Plan Amendment - lighting

RE: UNUM Light Fixtures  
CBL: 231-B-002

Amendment to Plan - UNUM Lighting

UNUM PROVIDENT  
Portland, Cumberland County  
EAST ENTRANCE STREET LIGHTING  
L-18486-26-N-M (approval)  
( ) FINDINGS OF FACT AND ORDER  
( ) MINOR MODIFICATION  
( ) SITE LOCATION OF DEVELOPMENT ACT

## REVISED GUARD RAIL LAYOUT EXCERPT OF SHEET C3

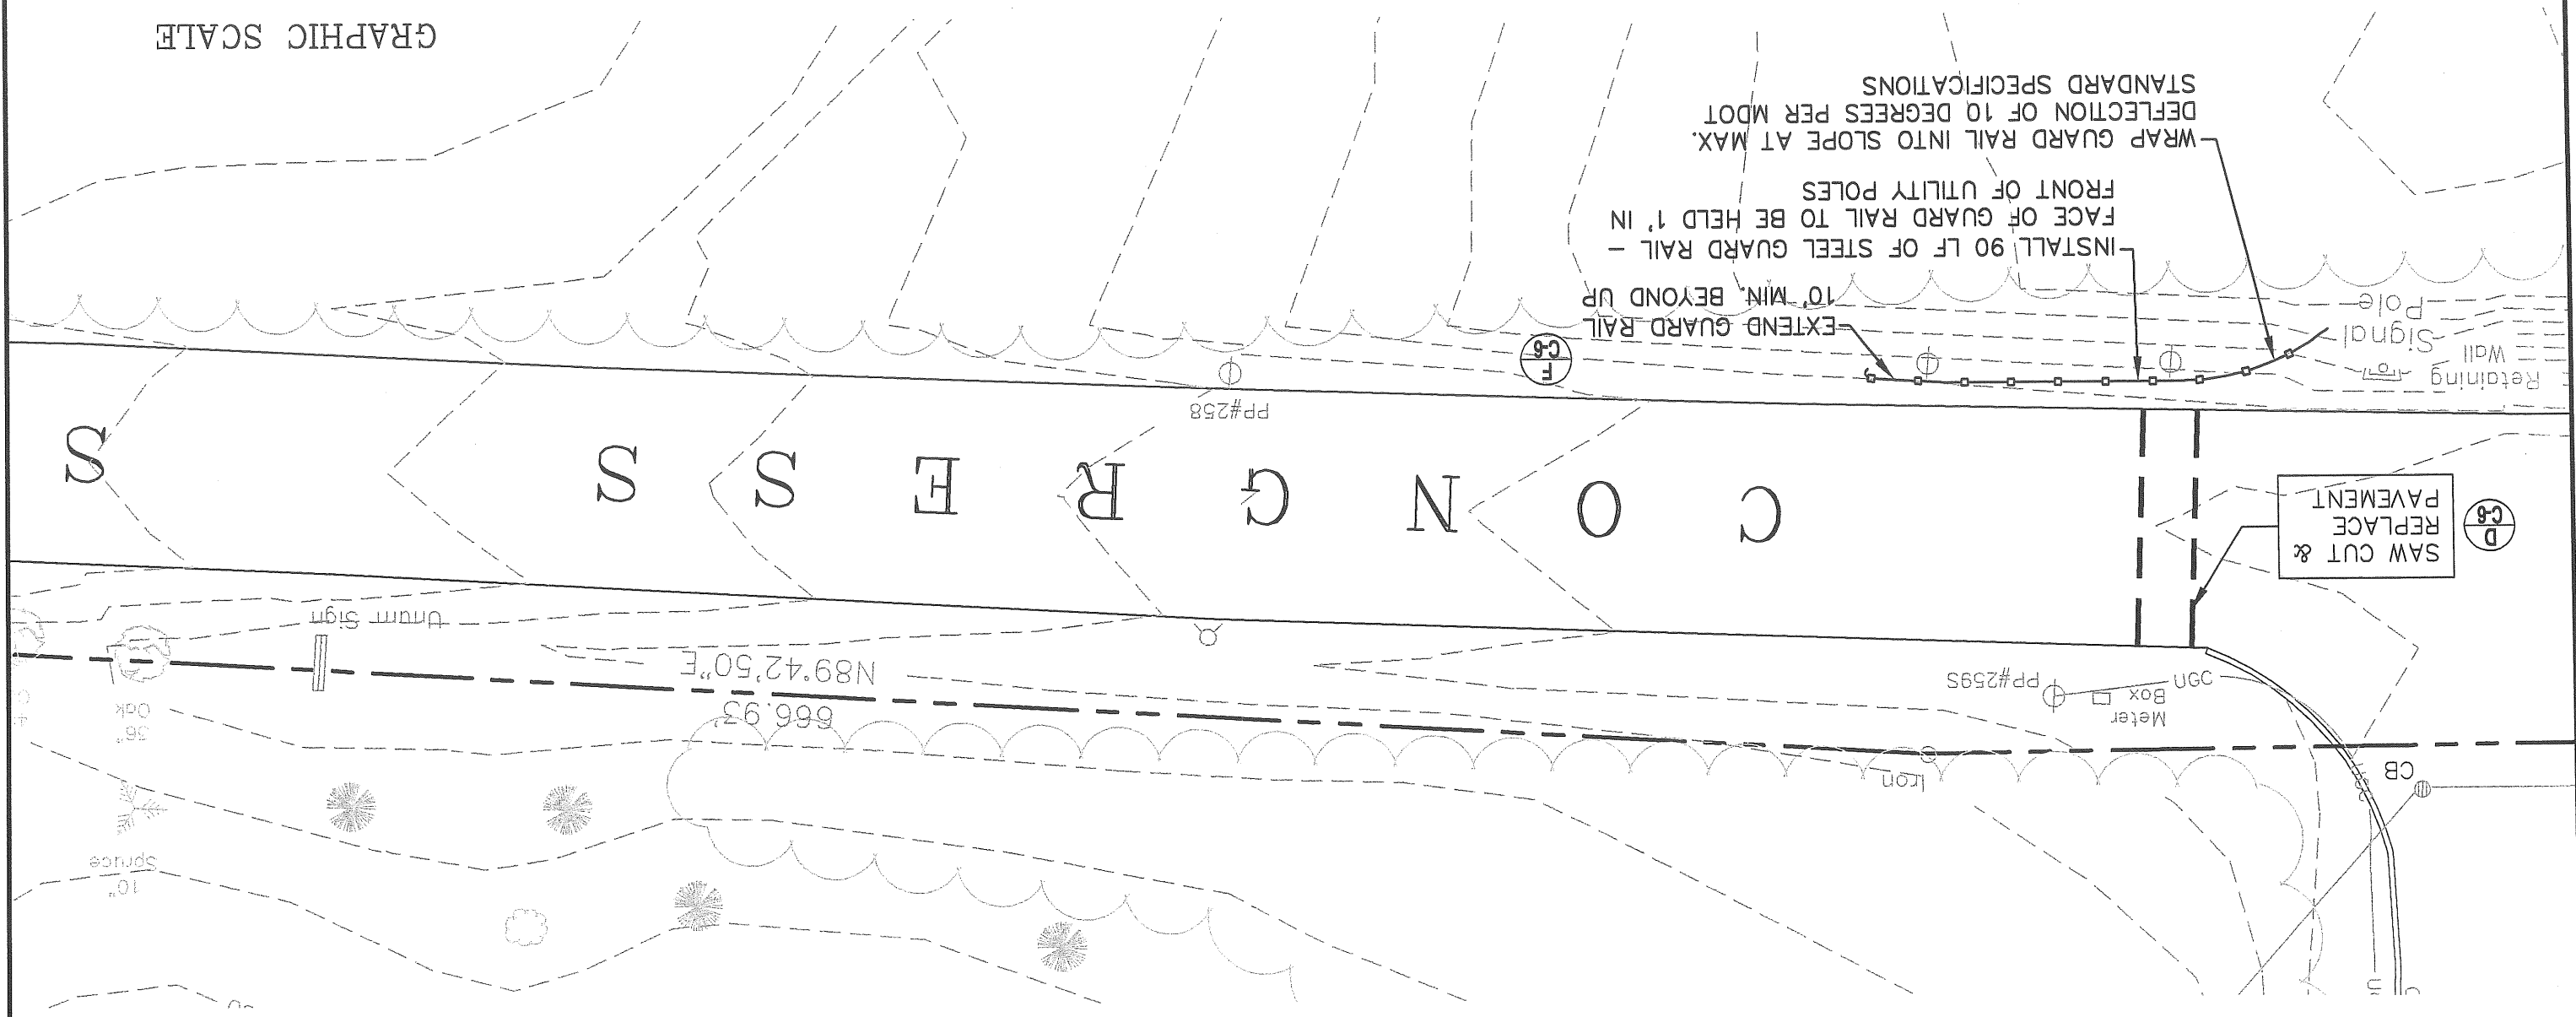
Our office has reviewed the guardrail to be placed in front of the utility poles along Route 22 near the main entrance to the UNUM campus with Eric Labelle at the City of Portland's Engineering Department. Mr. Labelle indicated that it would be acceptable to switch from the wooden guardrail approved to a steel guardrail. Attached please find figures SK-1 and SK-2, which show details of the steel guardrail detail UNUM Provident will be installing at this location.
